TECHNICAL INSTRUCTION

TI 160
Issue 1
25 May 2011
Page 1 of 17

Campaign Change – Conversion of Aster U/SF15 TC to Aster21 TC

Relevant Standard: TI 159

APPENDIX A

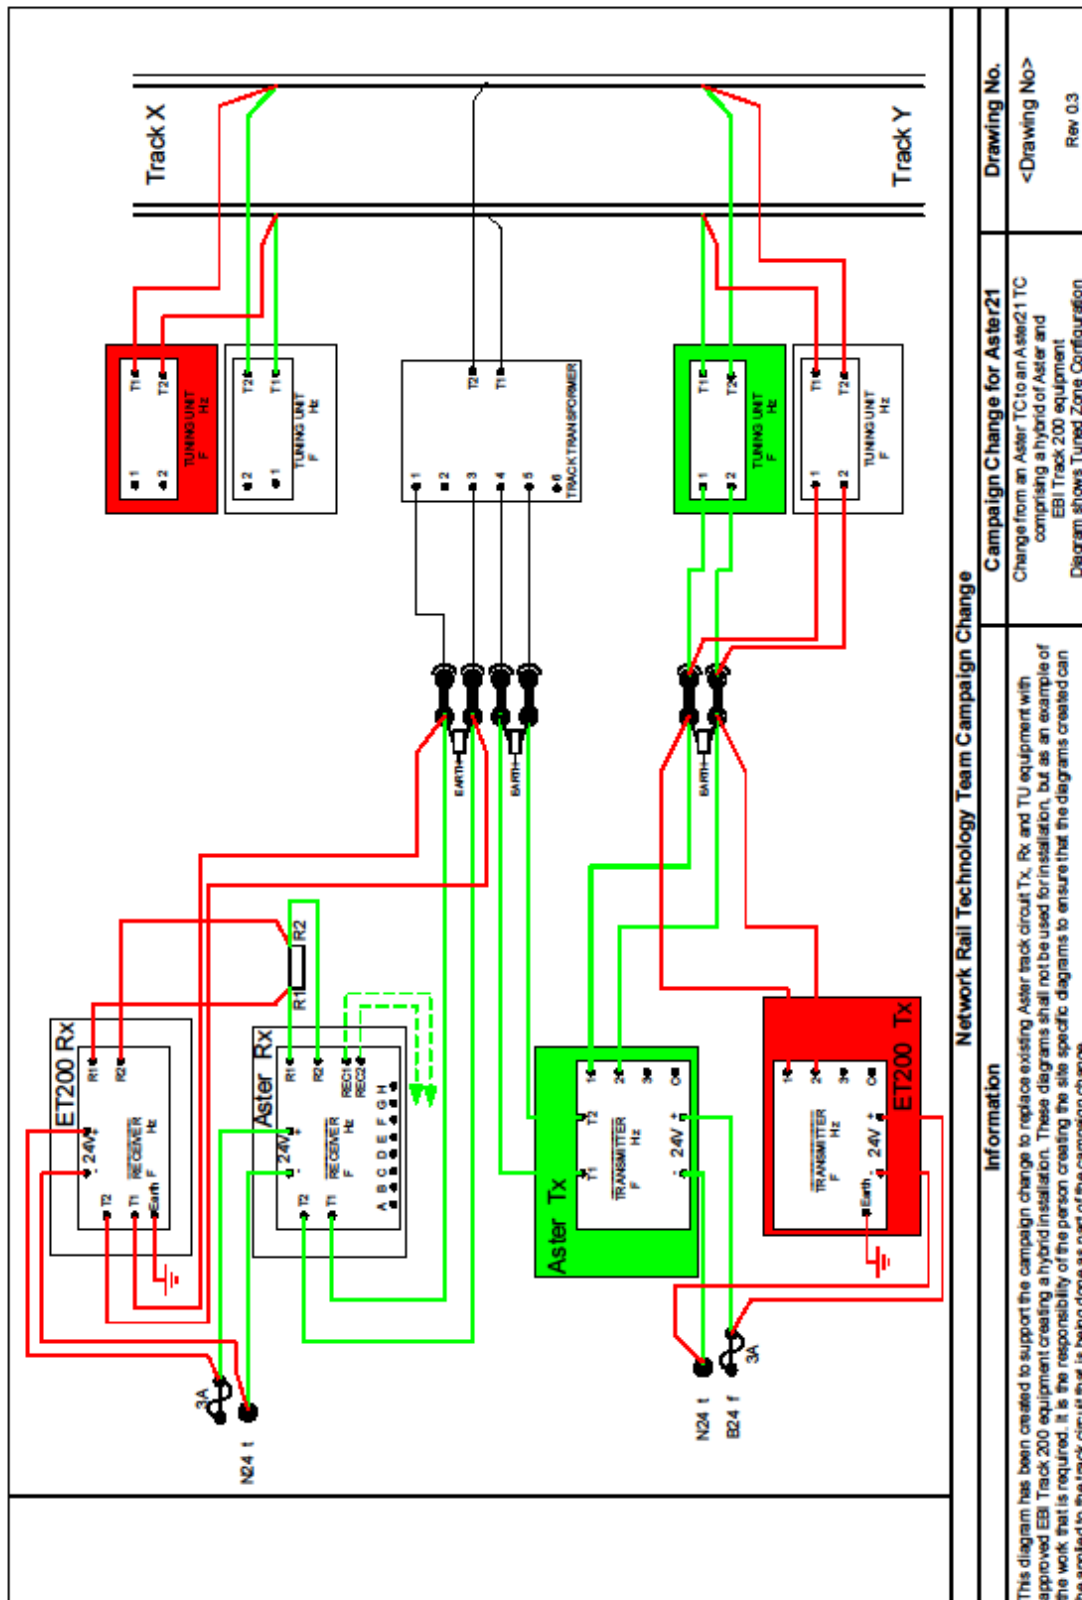
- An initial site assessment shall be made to consider the viability of performing the change using TI 159 and this TI. The current installation and circuitry shall be assessed in conjunction with the *example* diagram (see Appendix A) and allowable configurations (see Appendix B) to establish that the work can be achieved within the auspices of the TI and Test Plan.

The designer is required to understand the Aster architectures as described in the Aster Handbook BR134482/2 'Aster Type U Jointless Track Circuits for Non electrified Lines' dated October 1976. (This includes information on the SF15 equipment). Appendix A illustrates an equipment change for a typical Tx/Rx Tuned Zone scenario.
